CMI-331

AUDIO OUTPUT MODULE

FIELD CHANGE NOTICE

DESCRIPTION Audio Output Module

AUDIO CARD LAYOUT FOR CMI-331 LP TO REV 1B7.2

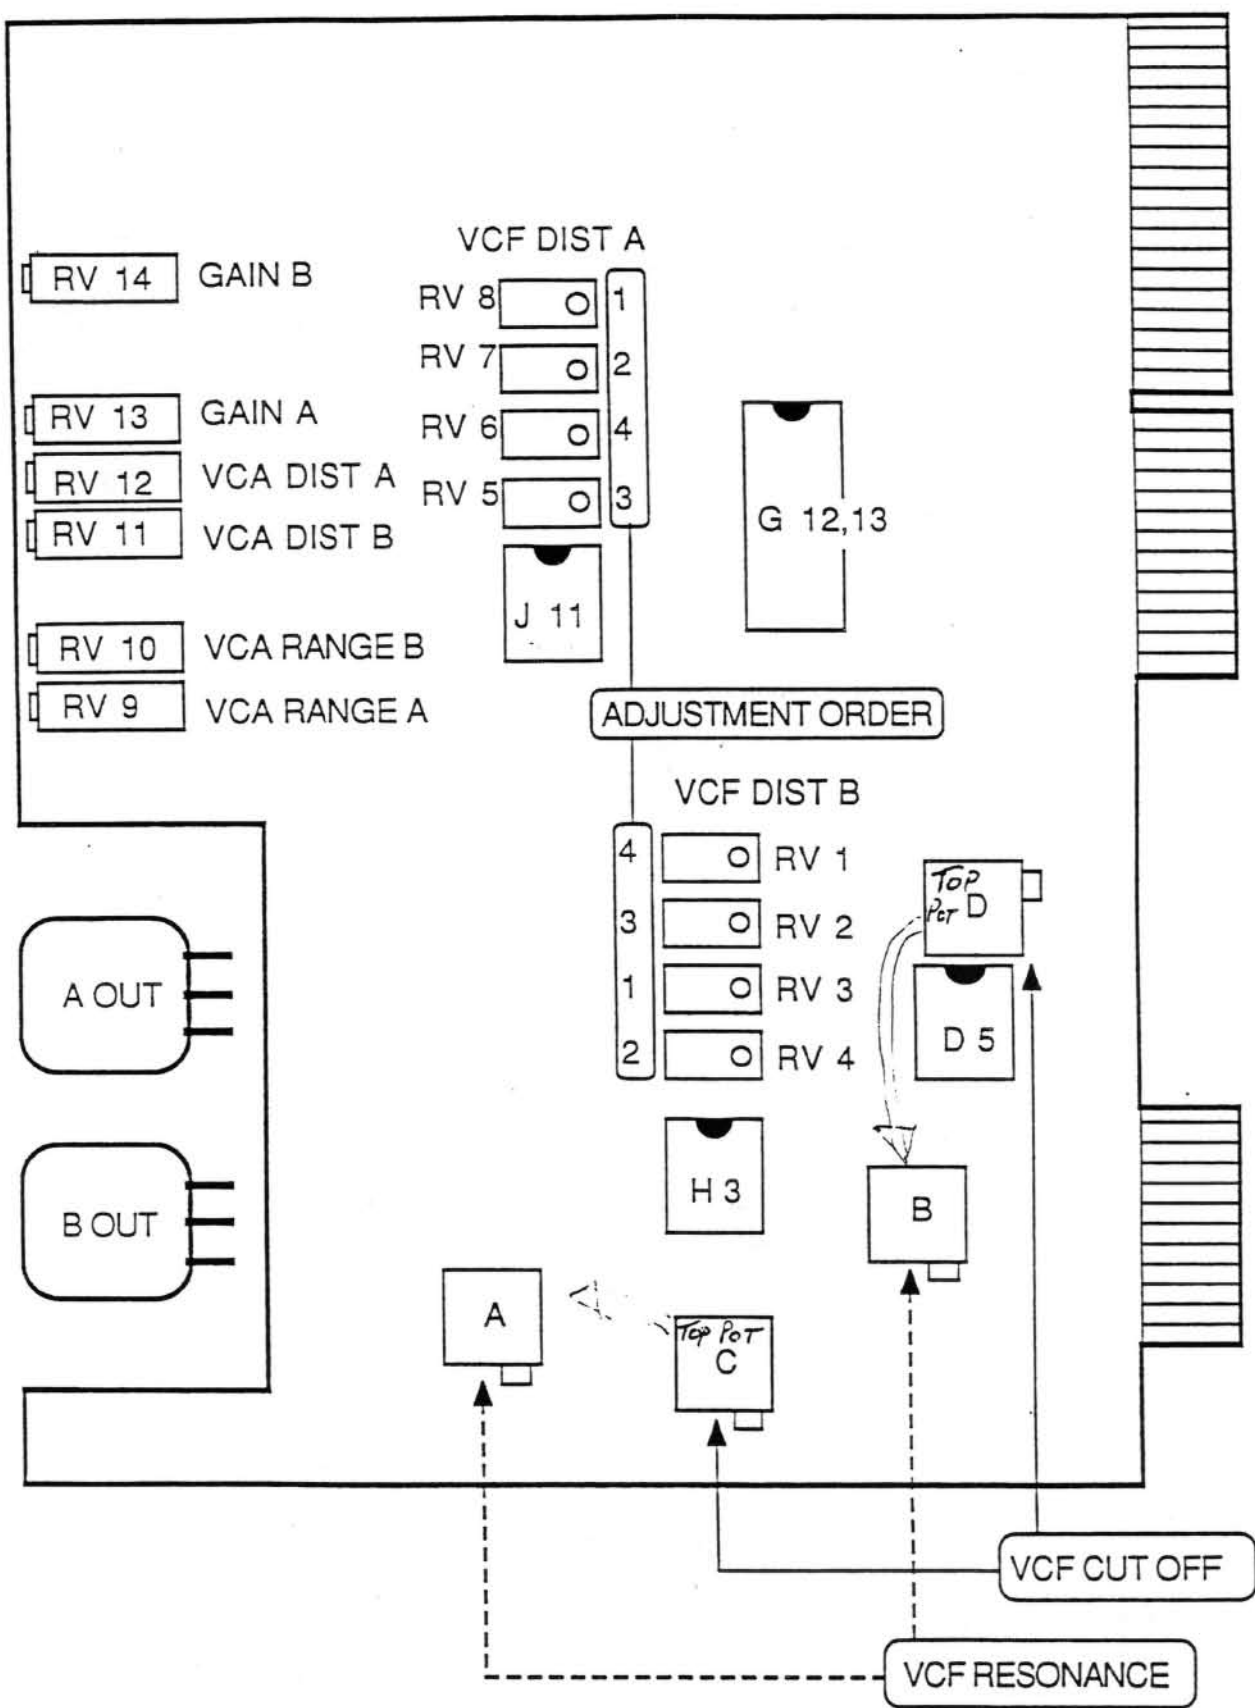
1. From shell type "kstart SPACE -c SPACE /k2/kmondiag" <return>
OR "wsdiag" <return>
2. Type "a" for audio calibration programme <return>
For each card Leave 5 mins. for temperature to stabilise.

3. Using multimeter : +ve lead connected to junction of R68 & pin 7 J1,2B (bottom R68) and -ve lead connected to junction of R63 & pin 1 J1,2A(left of R63). Adjust for 20 to 25 millivolts on bottom pot "A".

4. Using multimeter : +ve lead on 0v (left of R43) and -ve lead connected to junction of R63 & pin 1 J1,2A(left of R63). Adjust for -72 millivolts on top pot "C".

5. Using multimeter : +ve lead connected to junction of R27 & pin 7 J3,4B (top of R27) and -ve lead connected to junction of R26 & pin 1 D5A (left of R26). Adjust for 20 to 25 millivolts on bottom pot "B".

6. Using multimeter : +ve lead on 0v (left of R43) and -ve lead connected to junction of R26 & pin 1 D5A (left of R26). Adjust for -72 millivolts on top pot "D".

7. Using multimeter : -ve lead on 0v and +ve lead on centre of RV8, adjust for a reading of zero millivolts (+ / - 10mV). Repeat for RV7, RV6, RV5, RV4, RV3, RV2, RV1.
